TI_2217: Adjustment of stop buffer

iCombi Pro and iCombi Classic electric and gas 20-1/1 and 20-2/1

04/07/2022

New stop buffer:

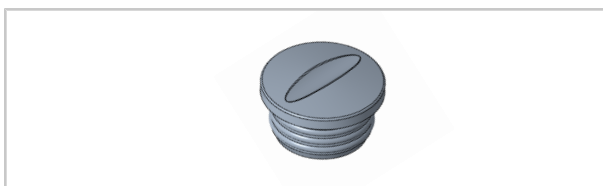
In order to prevent the stop buffer Art. no.: 24.05.002P from sticking to the front wall due to vacuum pressure or soiling, which could lead to loss, the stop buffer was adjusted.

The article number for the stop buffer remains unchanged.

only new stop buffers will be available.
